RAI 5:

Response to Request for Comment on Draft Safety Evaluation for AREVA Inc. Topical Report EMF-2328(P)(A), Revision 0, Supplement 1, Revision 0, "PWR Small Break LOCA Evaluation Model, S-RELAP5 Based" (TAC No. ME8227)

EMF-2328(NP)(A)
Revision 0
Supplement 1
Revision 0

PWR Small Break LOCA Evaluation Model,
S-RELAP5 Based

Figure 5-28: AFW Mass Flow Rate – W 4-Loop

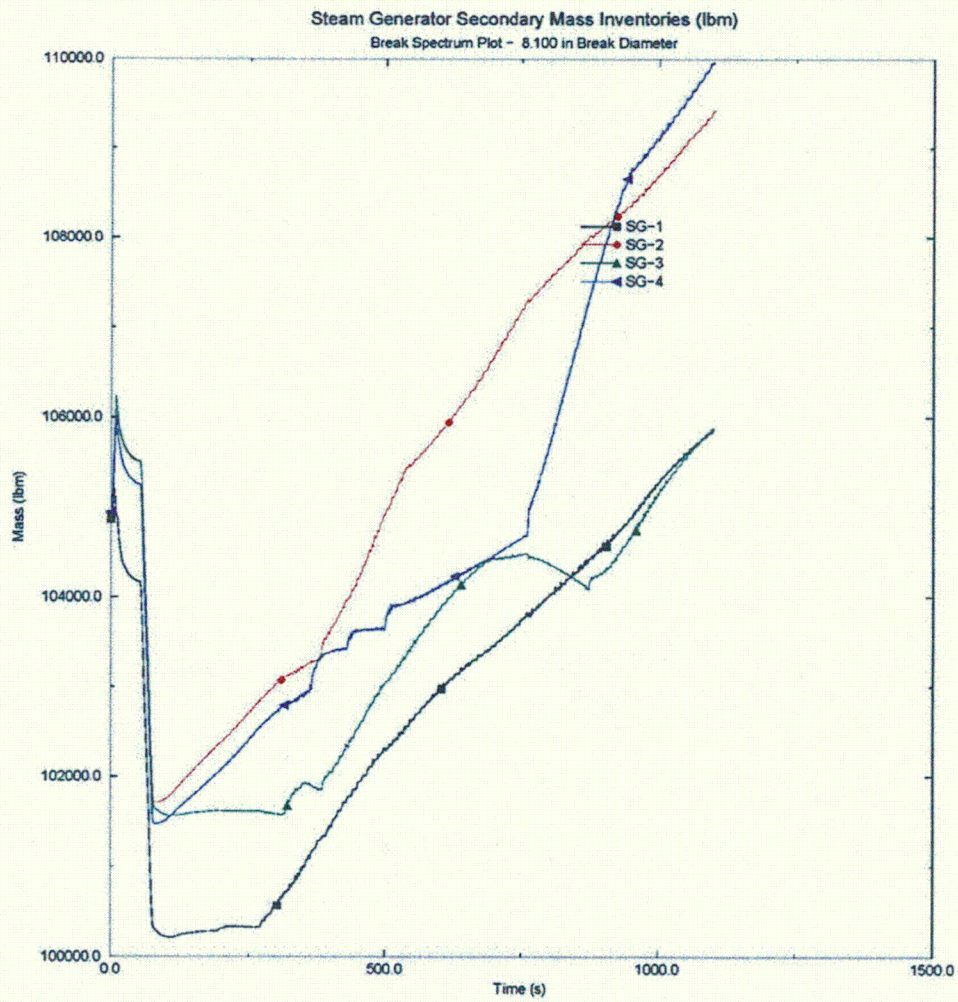
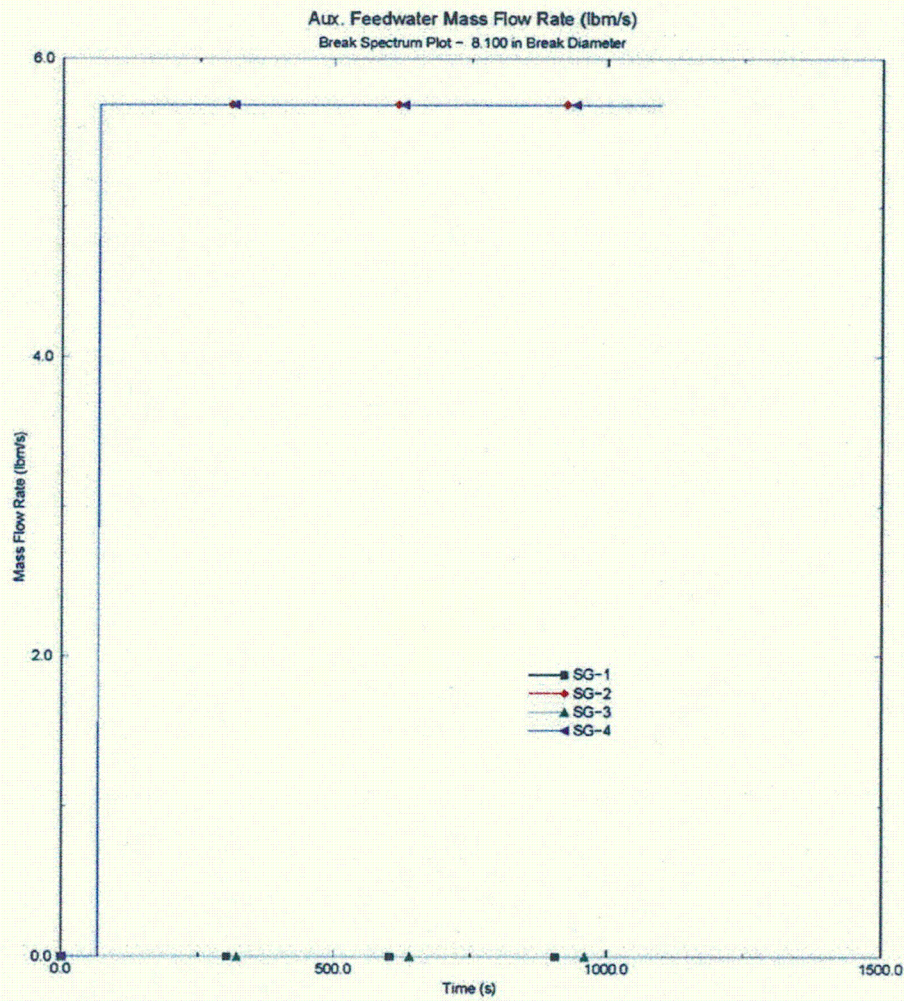
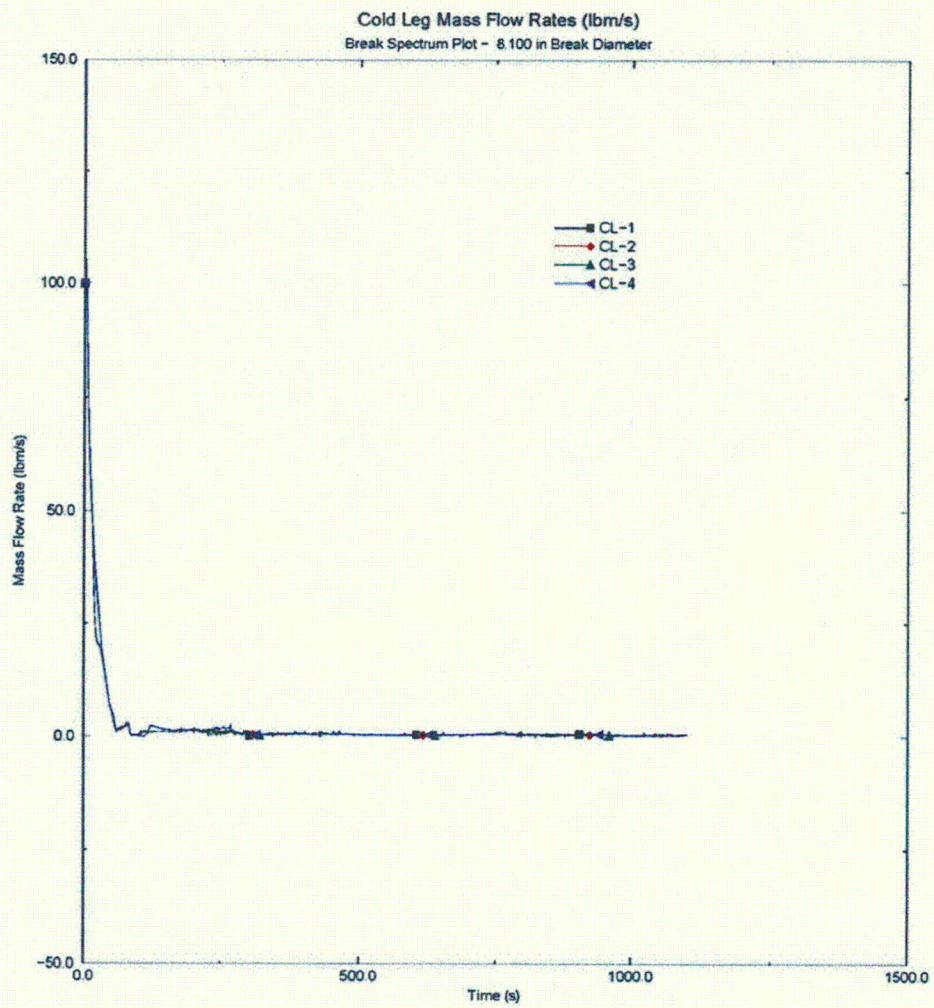
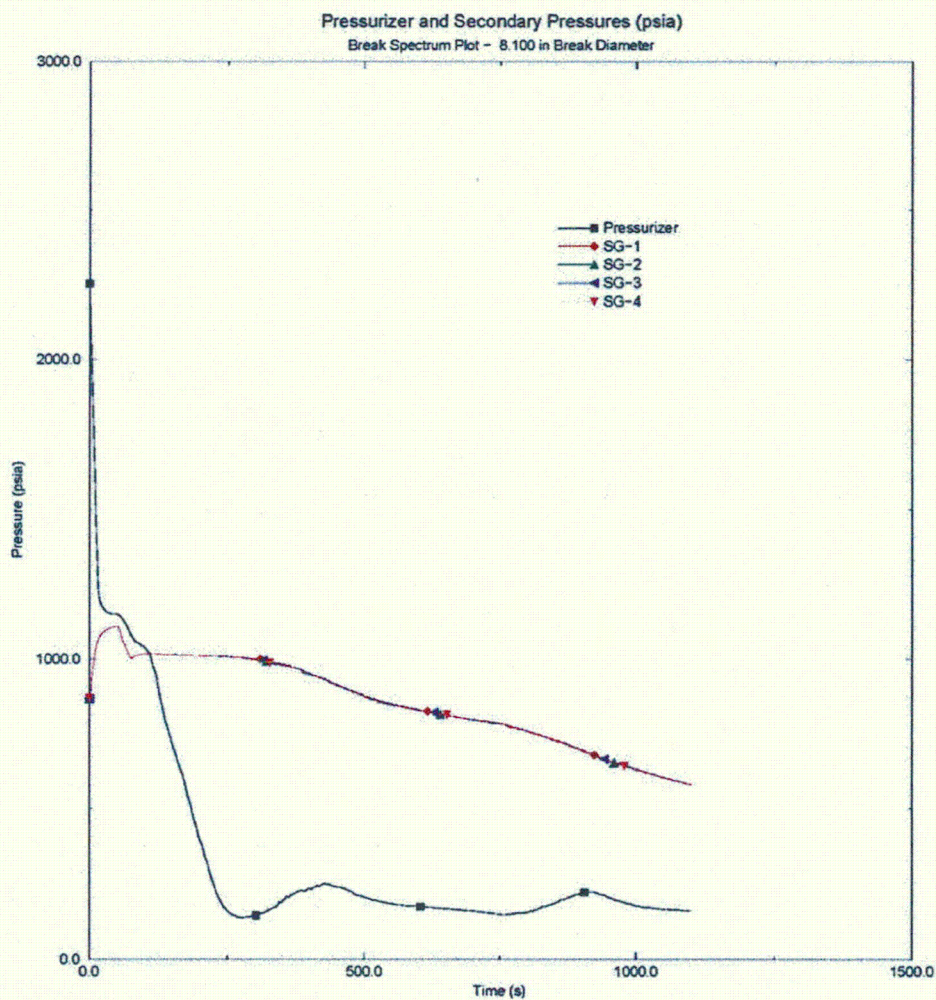
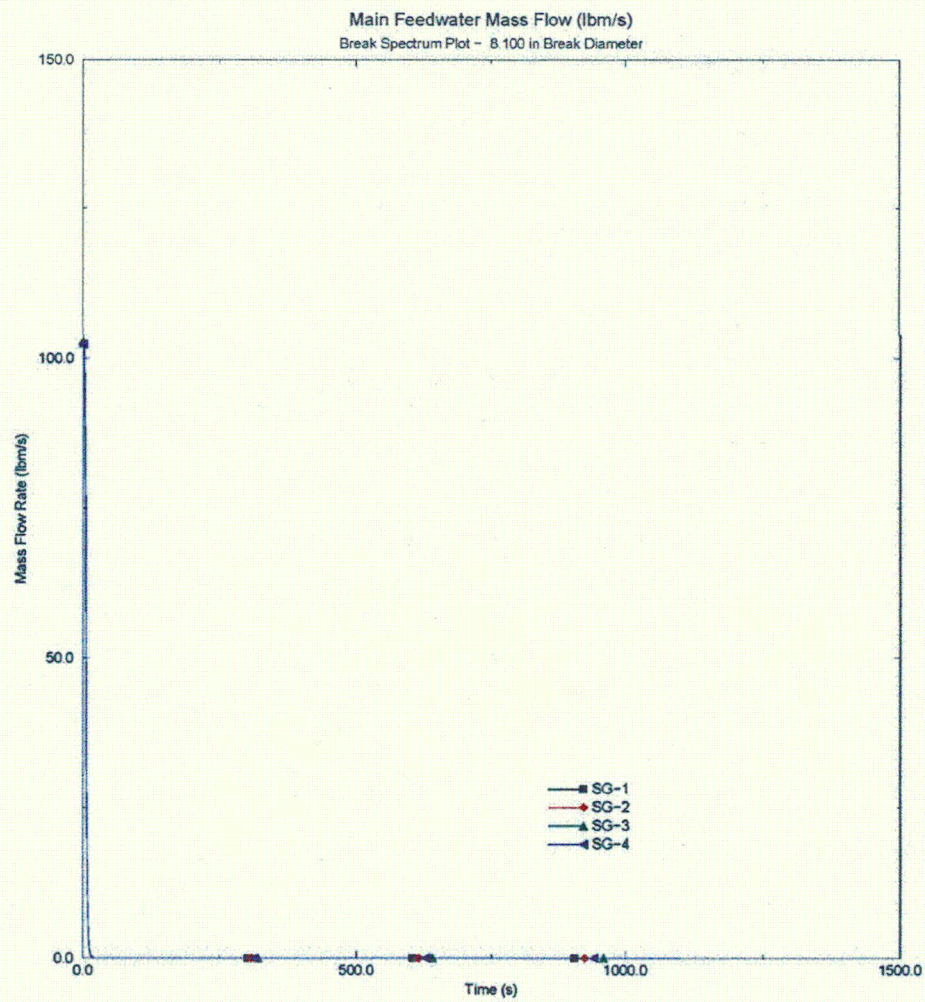
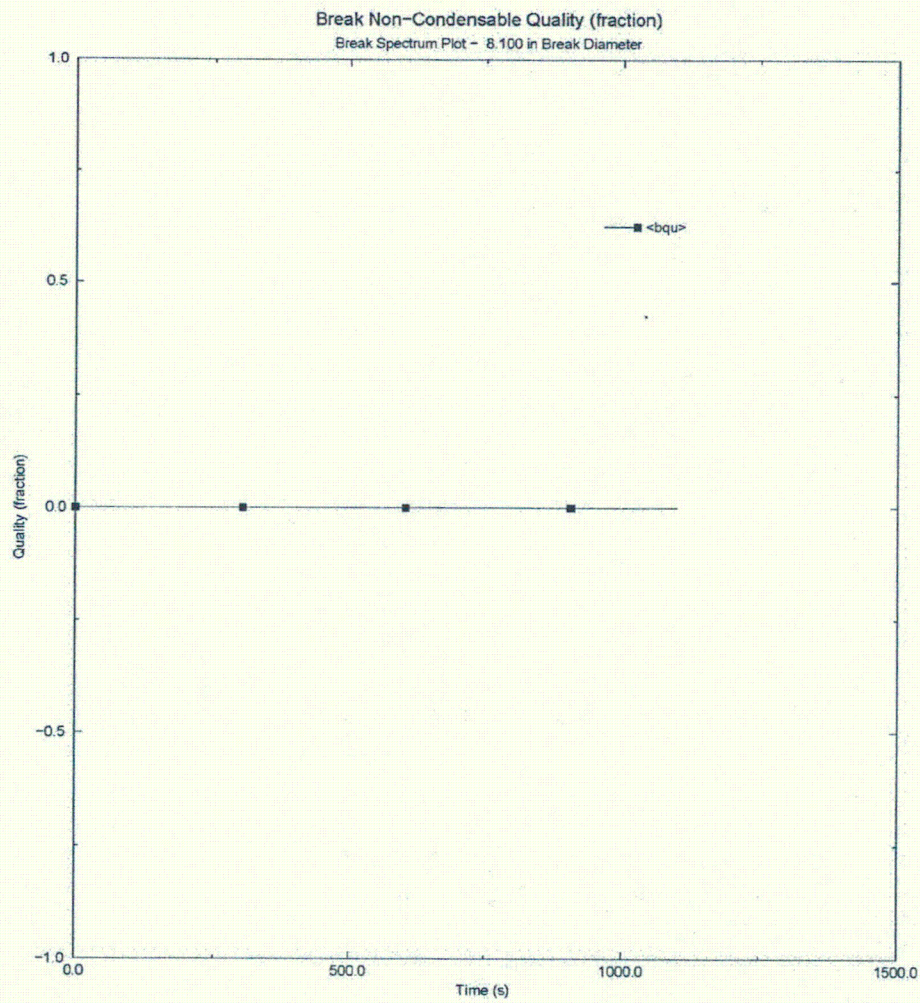
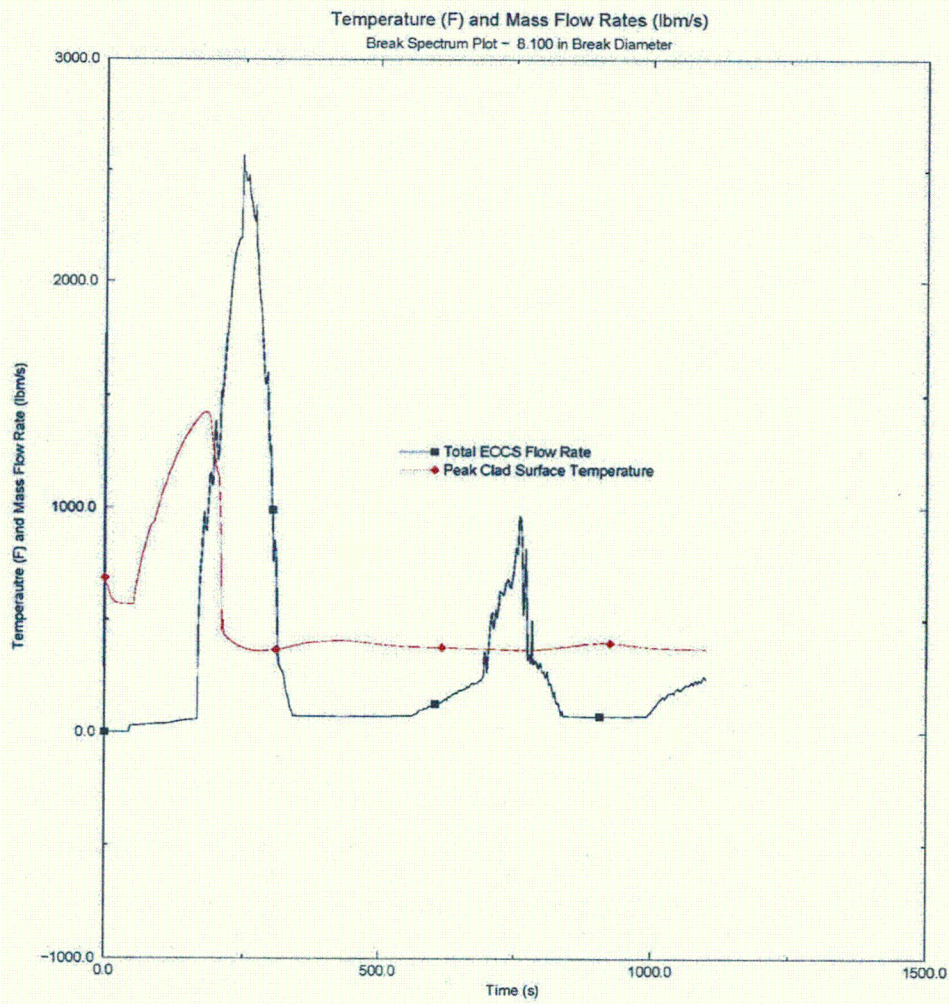
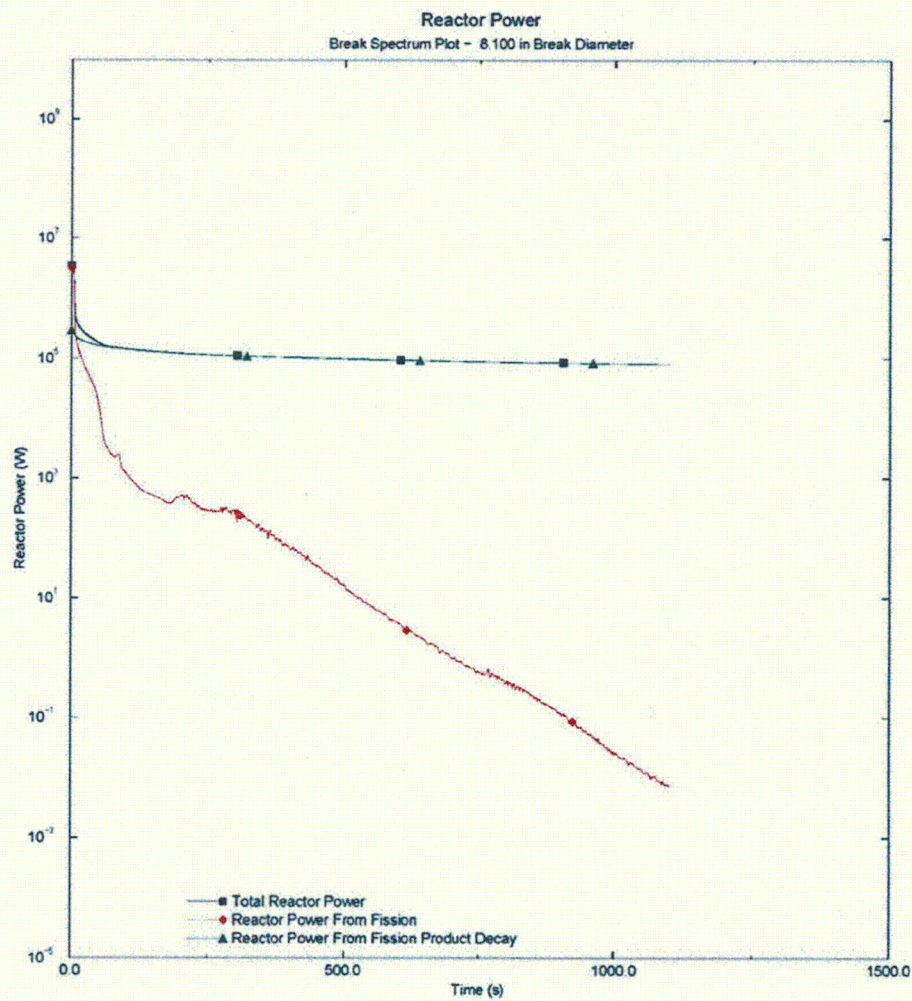
Please provide a plant sample break spectrum analysis with all of the EMF-2328(P)(A), Revision 0, Supplement 1, Revision 0, changes included. This could be accomplished by comparing the results of a sample plant SBLCOA spectrum with and without the EMF-2328(P)(A), Revision 0, Supplement 1, Revision 0, changes. This should include the severance of the safety injection line, as well.

The limiting break for a CLPD break and an accumulator line break are presented in Table 5-7 and Table 5-8, respectively. The results from the break spectrum analysis are presented in Table 5-9. The limiting PCT is 1429°F for a 8.10 inch equivalent pipe diameter break size. A listing of the sequence of events for each break size in the spectrum is shown in Table 5-10a through Table 5-10d. Plots of some of the more important parameters for the limiting break of 8.10 inches are presented in Figure 5-17 through Figure 5-34.

A double ended break in the accumulator piping connecting to the RCS does not produce a limiting case. An acceptable amount of emergency core cooling flow is delivered to the intact loops.
